Review and Recommendations:
WESTCAPS/U.S. Bureau of Reclamation Replication
of the Arizona Department of Water Resources
Current Trends Alternative Simulation

Prepared for:
U.S. Bureau of Reclamation
Phoenix Office

Prepared by:
Peter A. Mock & Associates, Inc.

Subject: Transmittal of Review Report – BOR Replication of Current Trends
Alternative for WESTCAPS

**Figure A-6: Differences of Simulated
Lower Alluvial Unit (layer 3)
Water-level Elevations (ADWR minus BOR)**

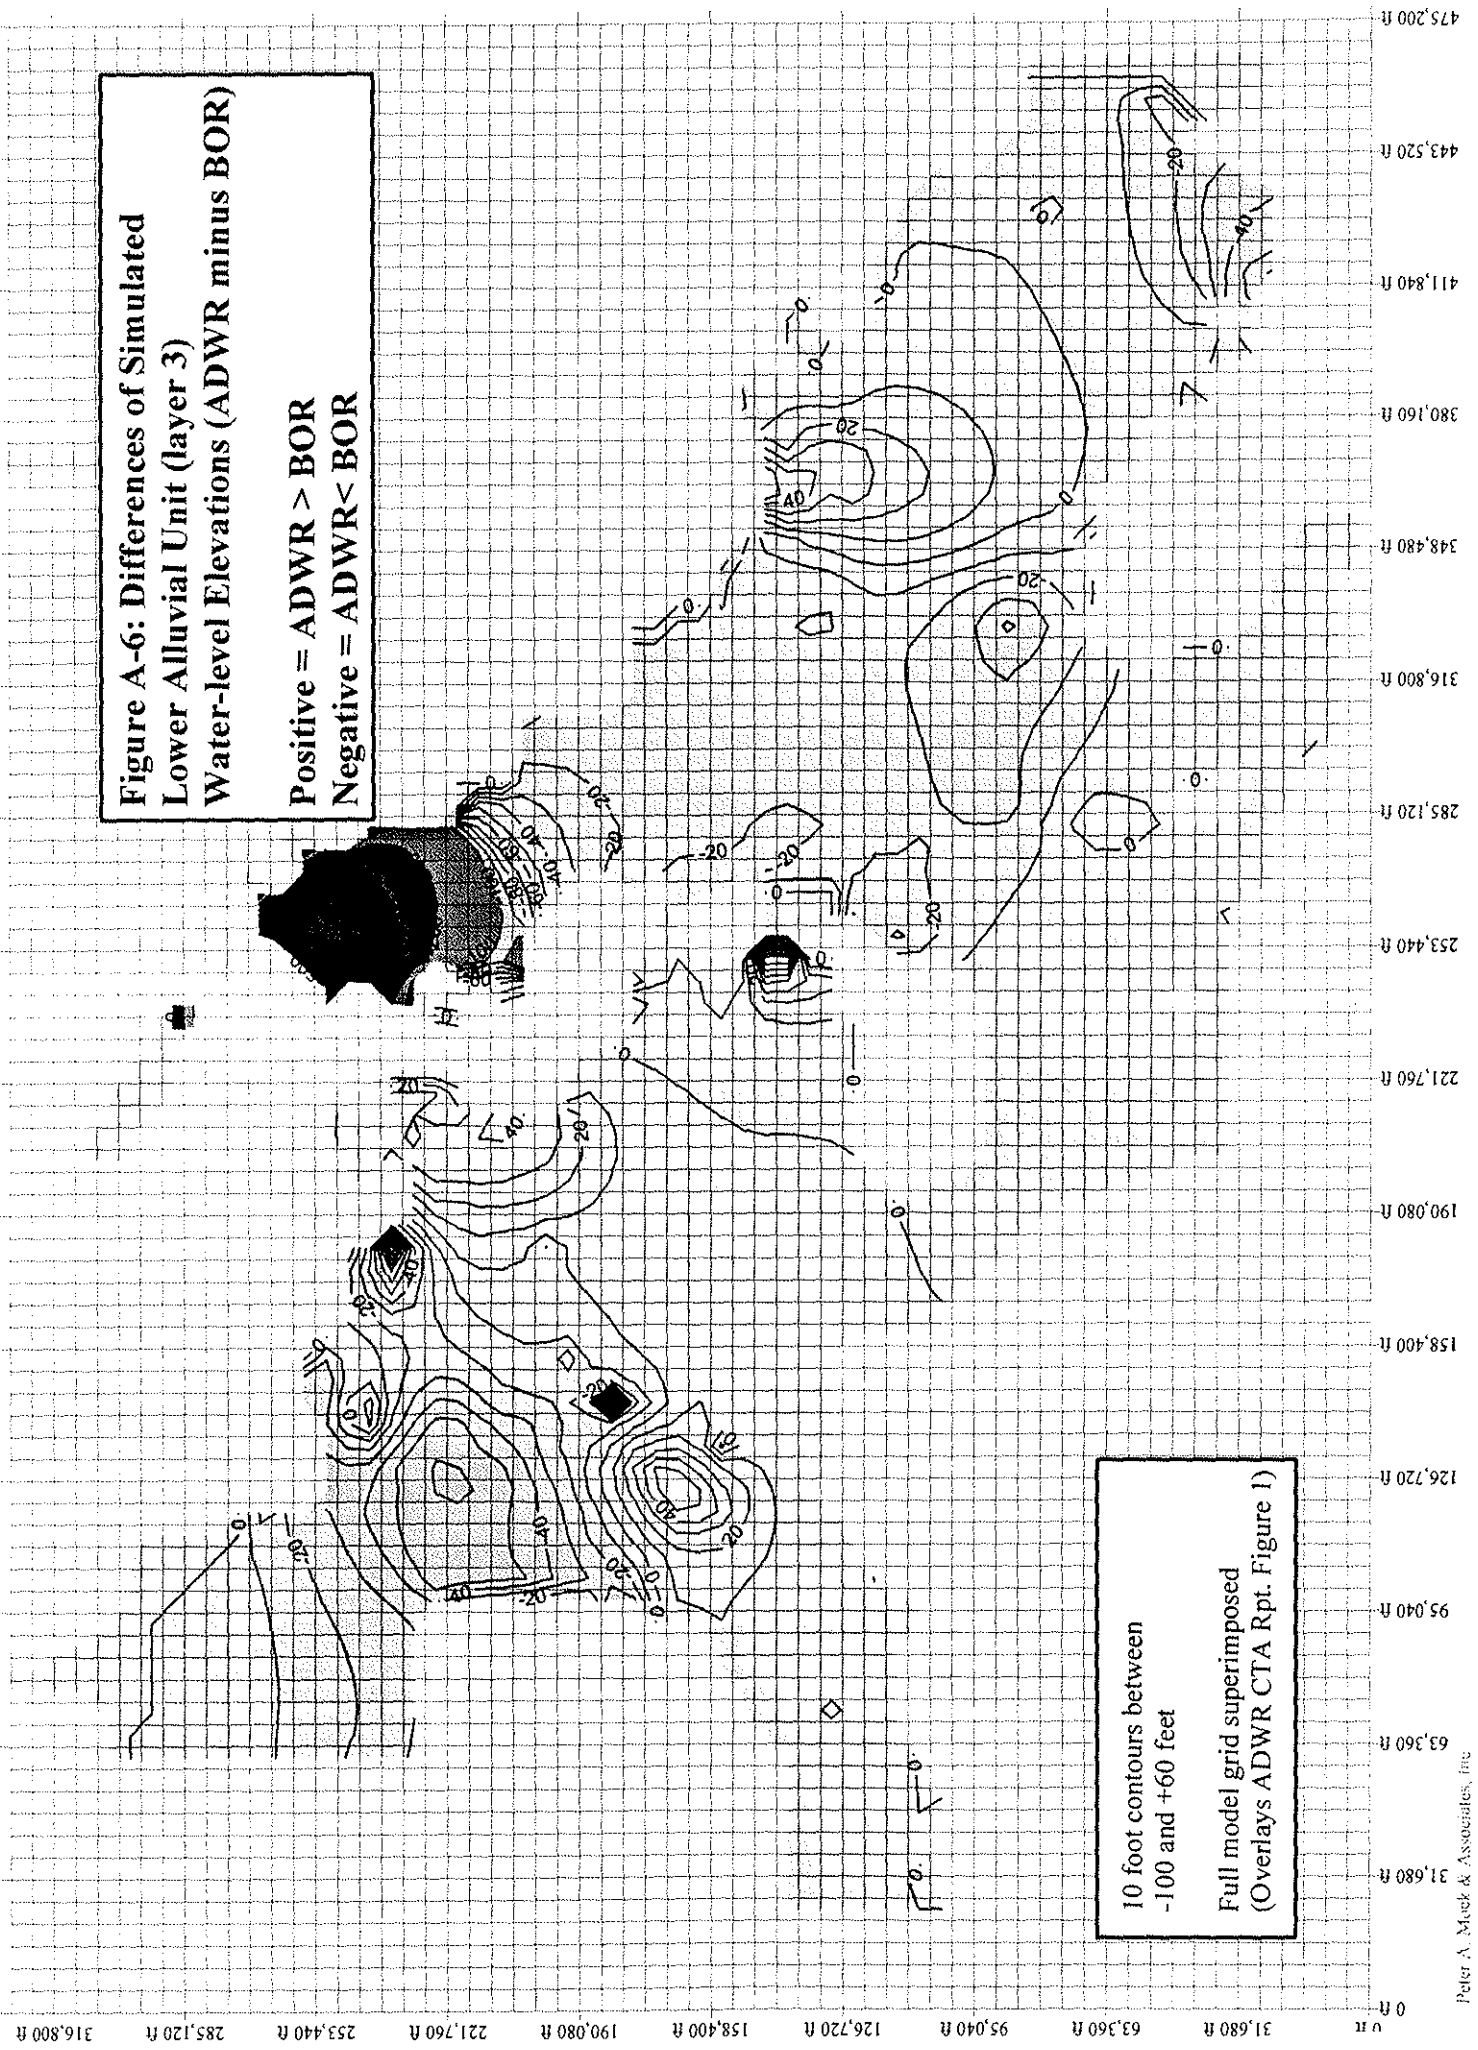
Inspection of Figure A-6 indicates that the differences are between 0 and 20 feet over much of the LAU. Exceptions include seven local areas of differences greater than 20 feet in ESRV, five local areas of differences greater than 20 feet in WSRV, and one area of difference greater than 20 feet where flow from ESRV joins the WSRV. Less pumping by BOR than ADWR results in the area of negative differences in a large area of the northwestern WSRV. An adjacent area of positive differences greater than 20 feet in WSRV is attributed to greater pumping rates applied by BOR in the LPSCO area compared to the ADWR-CTA pumping rates.

Figure A-7: Simulated Upper Alluvial Unit Hydrographs

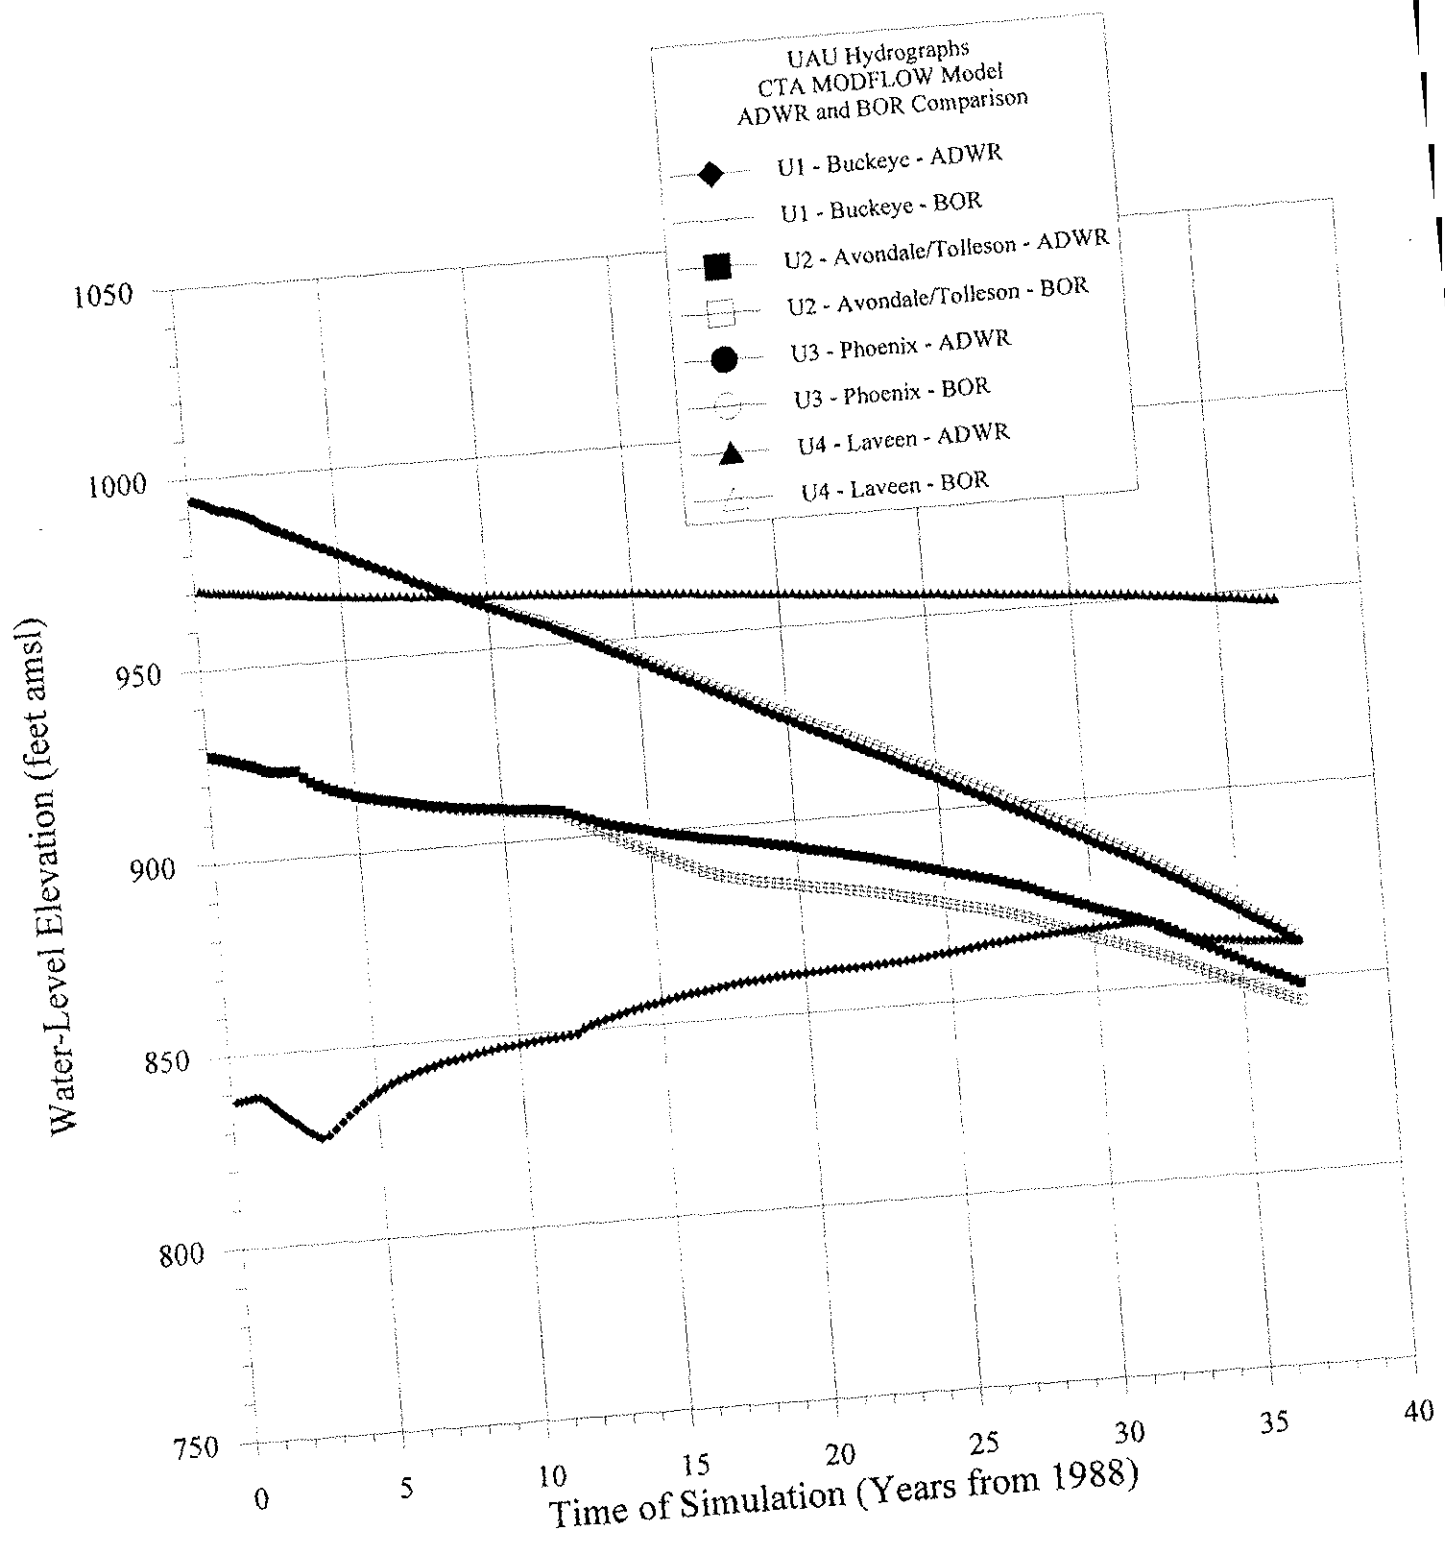
Figure A-7 shows the hydrographs simulated in the UAU layer for the Buckeye, Avondale/Tolleson, Central Phoenix, and Laveen locations. The other locations (Luke Sink and North of the White Tank Mountains) are dewatered in the UAU of the SRV model. The only clearly recognizable difference is a greater drawdown in the Avondale/Tolleson area in the BOR-CTA after approximately 12 years of simulation. The greatest difference is approximately 10 feet. The noted differences are considered acceptable given that the hydrograph shapes are similar.

Figure A-8 Simulated Middle Alluvial Unit Hydrographs

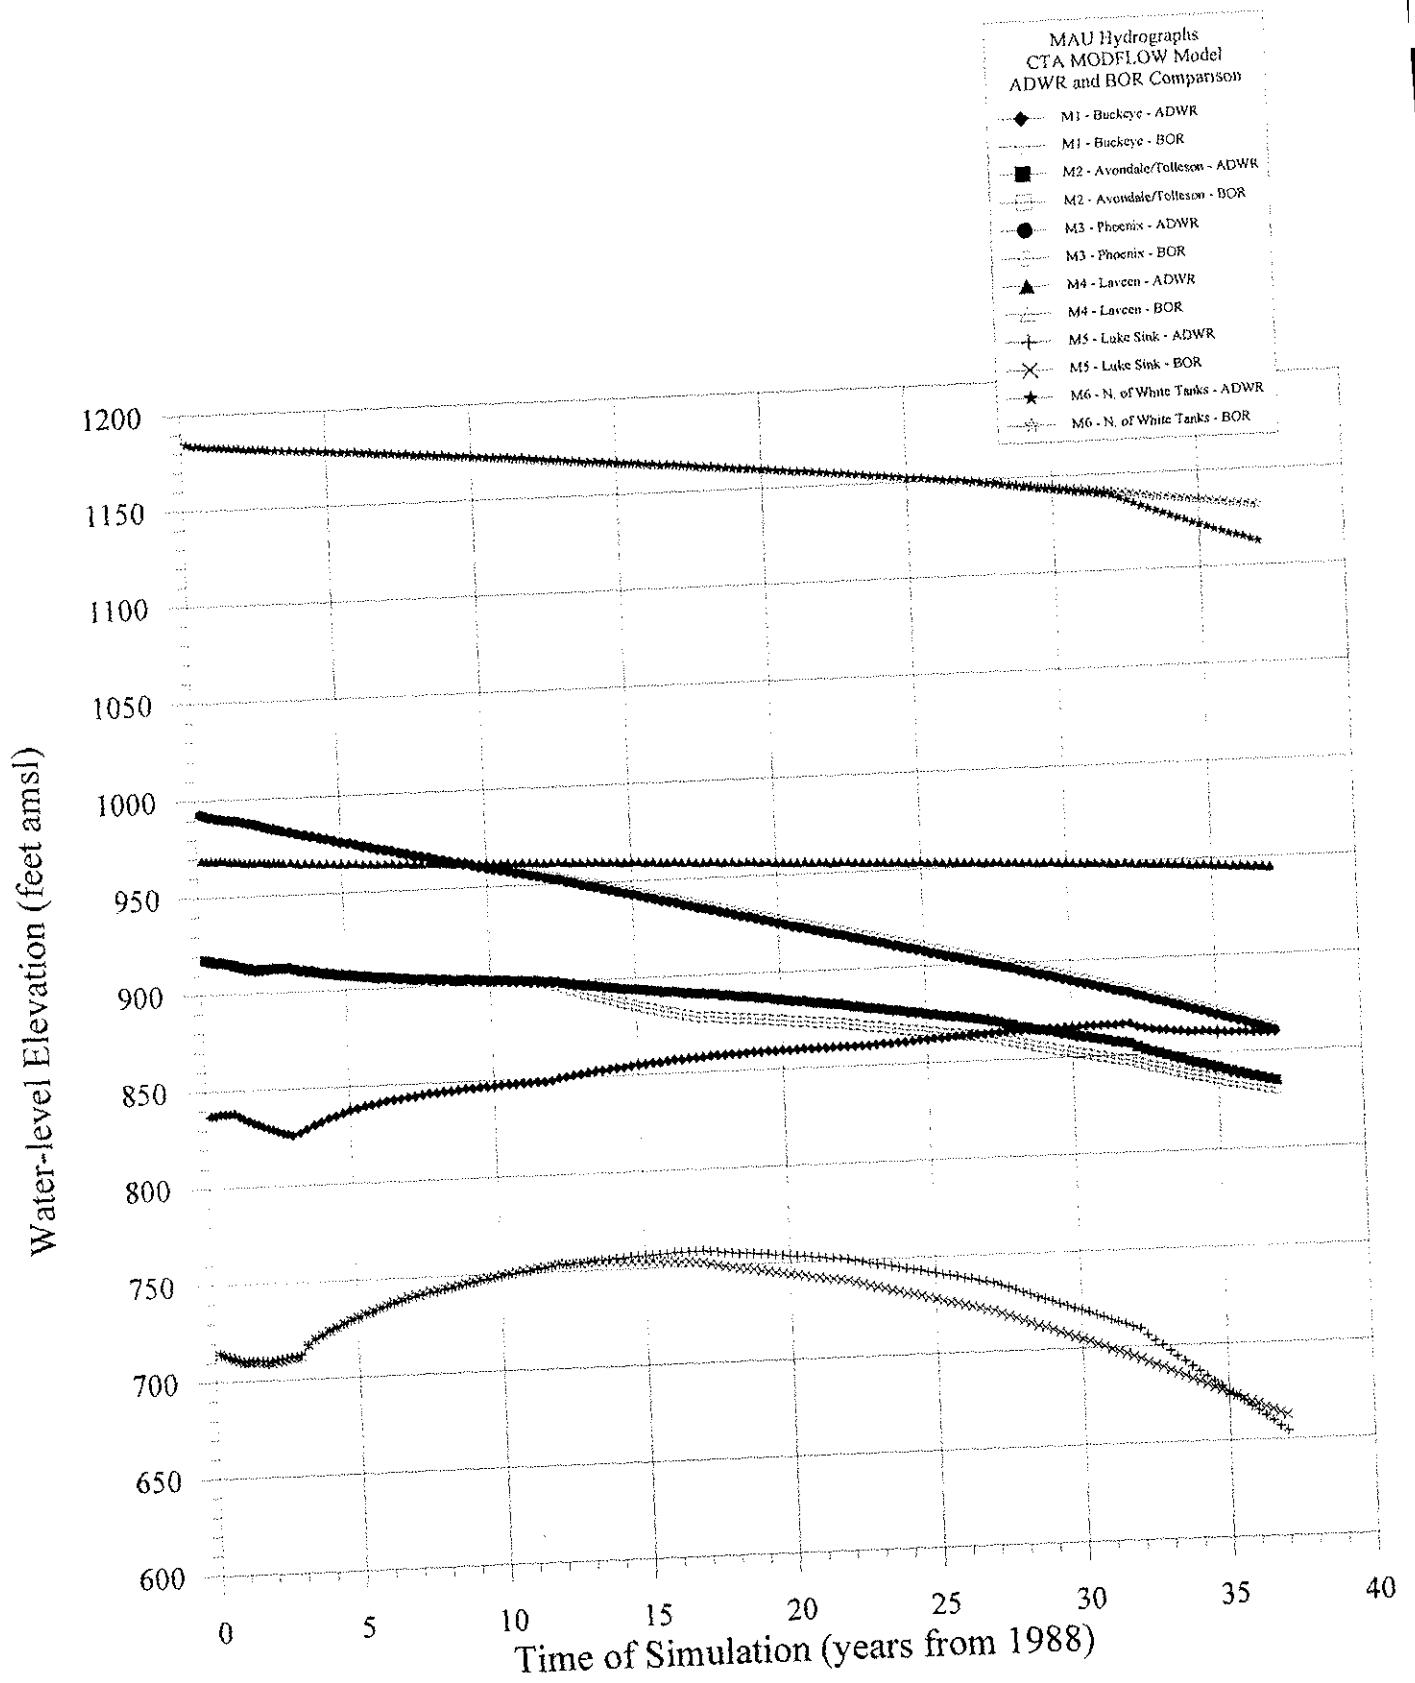
Figure A-8 shows the hydrographs simulated in the MAU for the six locations listed above. The difference in drawdown over time noted in the UAU near Avondale/Tolleson is also noted in the MAU. The BOR-CTA simulates more drawdown in the Luke Sink MAU between 14 and 35 years into the simulation when the ADWR-CTA catches up and then simulates greater drawdown. The ADWR-CTA simulates suddenly greater drawdown north of the White Tanks Mountains in the MAU after 32 years into simulation. The noted differences are considered acceptable given that the hydrograph shapes are similar.

Figure A-9: Simulated Lower Alluvial Unit Hydrographs

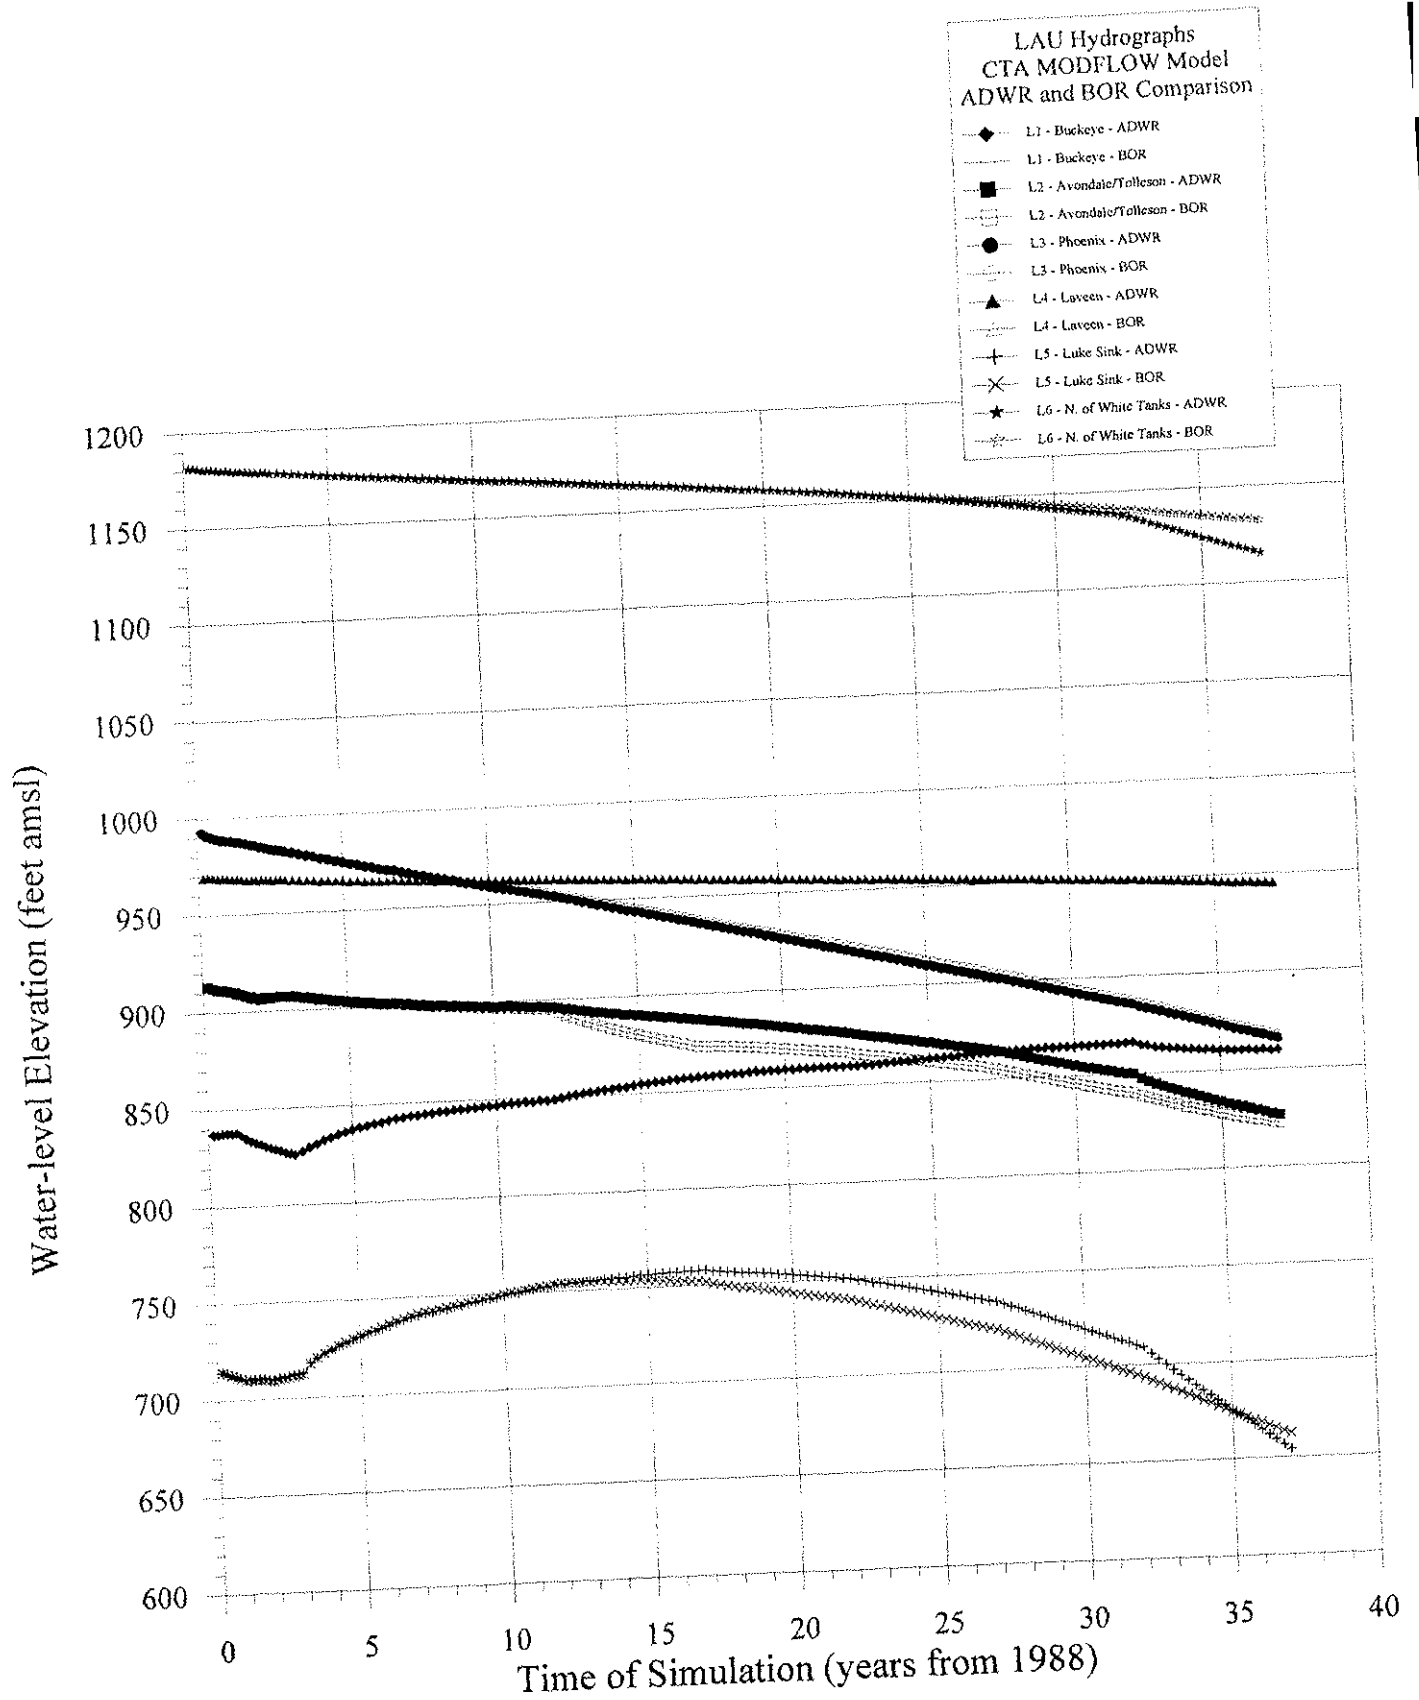
Figure A-8 shows the hydrographs simulated in the LAU for the six locations listed above. The LAU hydrographs are visibly similar to those in the MAU (Figure A-8) and similar differences are noted. The noted differences are considered acceptable given that the hydrograph shapes are similar.
